REVISED  
ENVIRONMENTAL IMPACT STATEMENT  
PANIAU  
LALAMILO, SOUTH KOHALA, HAWAII

Prepared Pursuant to Chapter 343, HRS

Gerald Park  
Urban Planner  
Honolulu, Hawaii

CONSULTATION PERIOD  
COMMENTS AND RESPONSES

Figure 2  
Proposed Site Plan

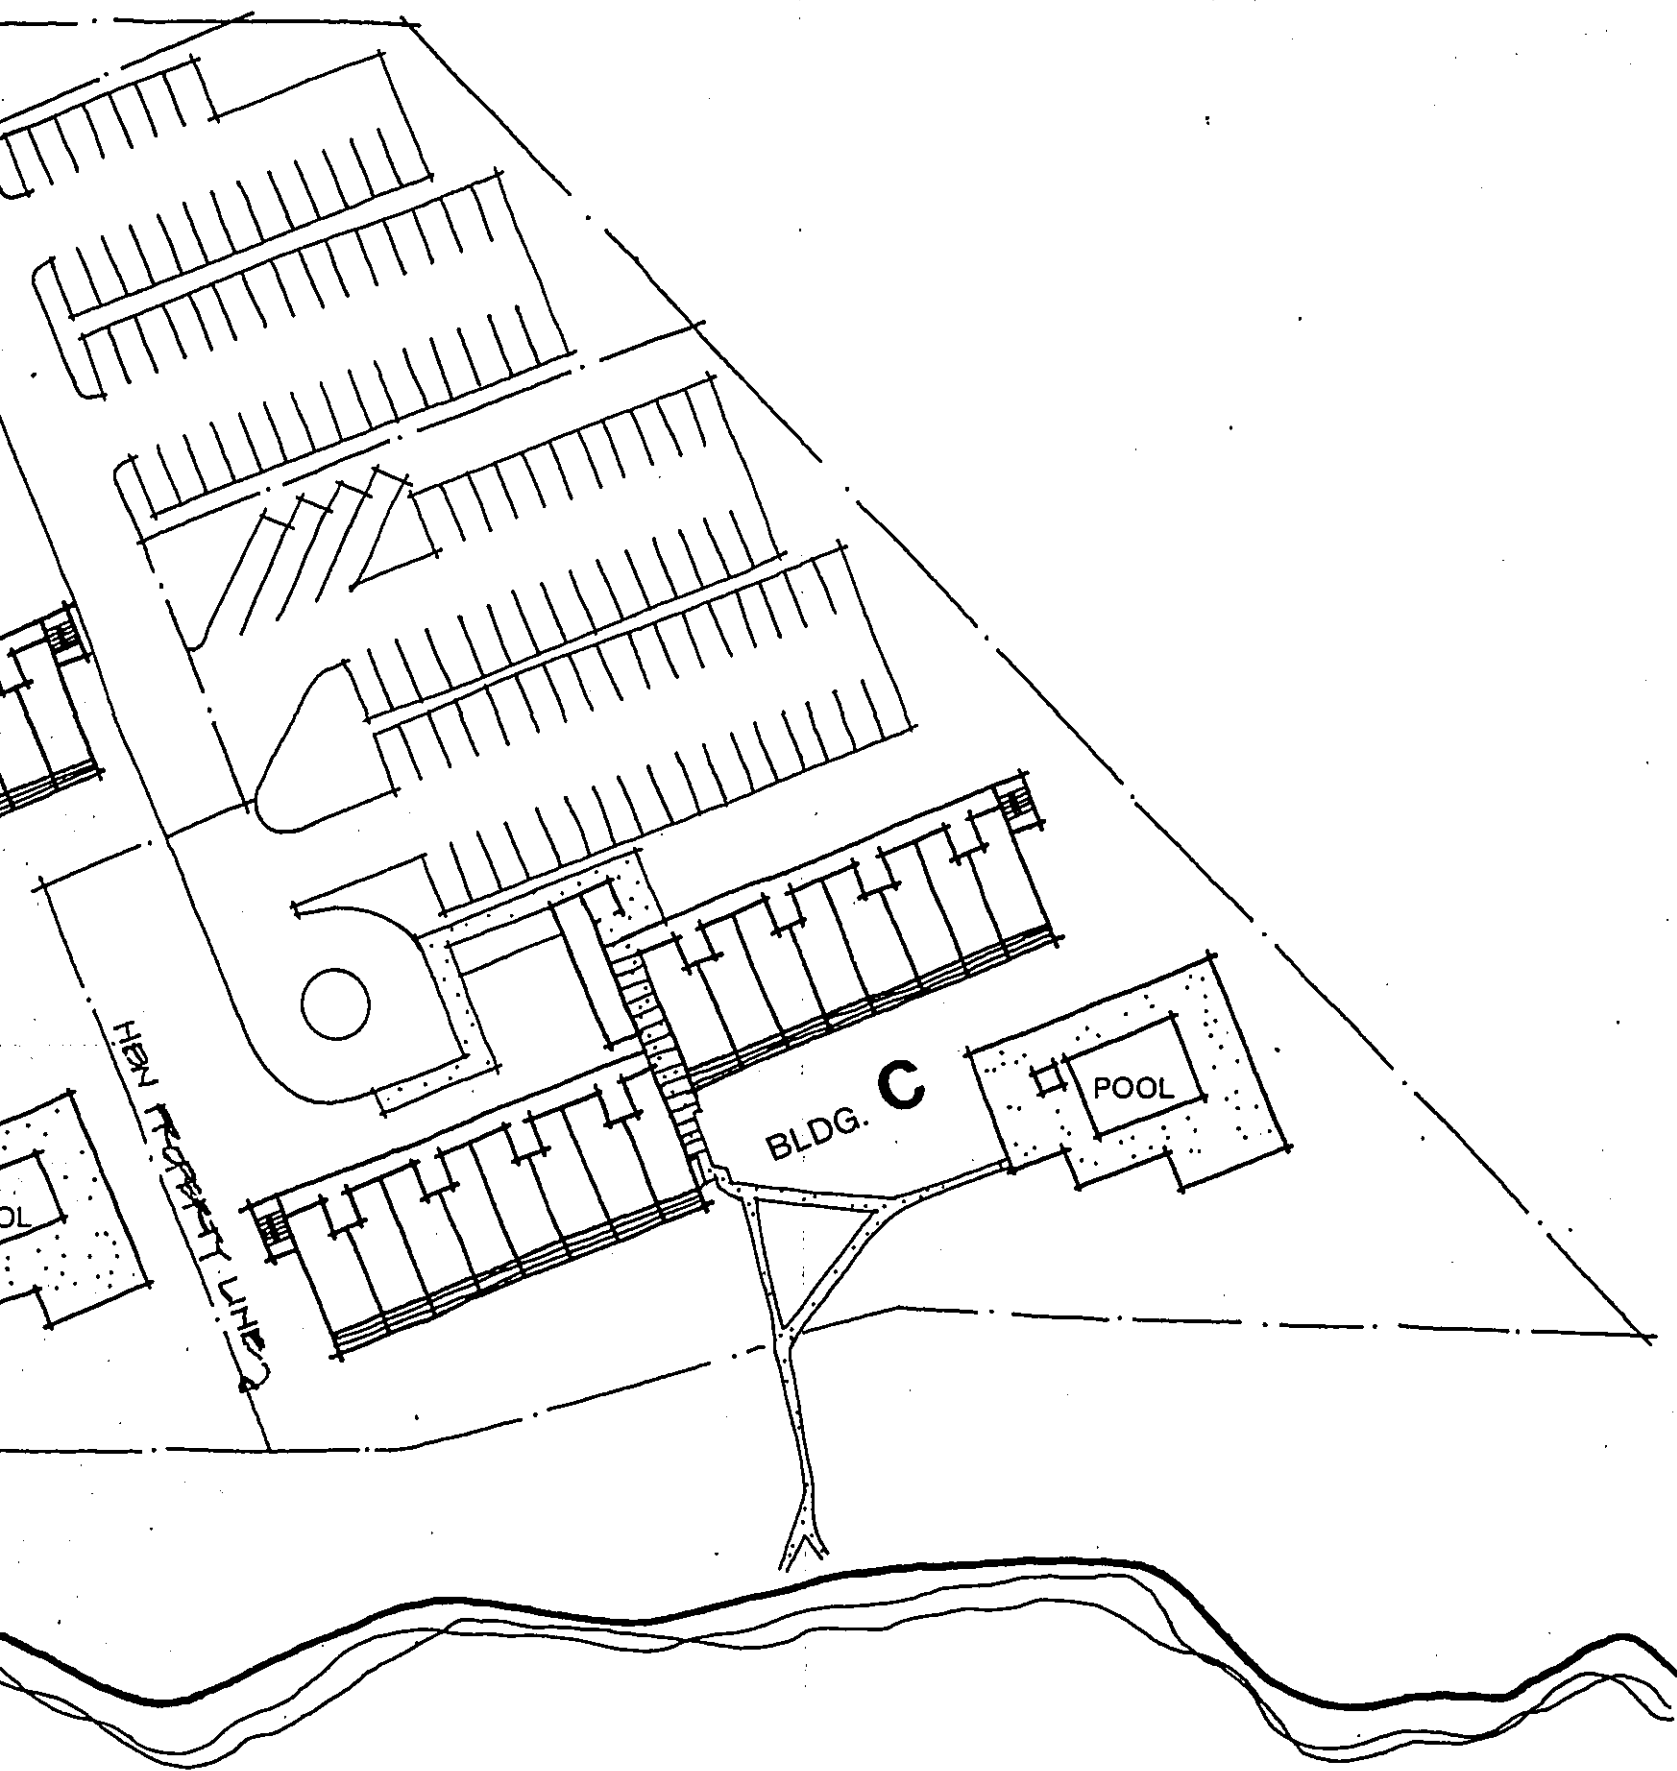
1. While specific site design aspects are not particularly critical at this General Plan amendment stage of the proposal, please be advised that minimum parking requirements are calculated at 1.25 stalls per unit. Therefore the 199 parking stalls mentioned on page 1 of the EIS is an underestimation and that at minimum 240 parking stalls would be required for the proposed project.

3. The EIS should include a site plan locating the archaeological sites superimposed by the proposed building and parking layout.
4. In calculating water demand requirements, the figure of 200 gallons/bedroom/day was used to estimate demand at 38,400 gpd. Please be advised that the Department of Water Supply

1. Access. The site plan indicates access to an extension of Puako Drive. This extension is yet to be built. Moreover, it is located on State land, and approval of the extension by the Board of Land and Natural Resources is needed before the extension can be constructed.

It is also possible that the buildings may be sited differently than depicted in Figure 2 of the EIS. An alternative site plan would be based on the location of archeological sites to be preserved, maintaining of existing anchialine pools or the location of a replacement habit (if this option is indeed the "best" solution), and composition of the underlying geological strata.
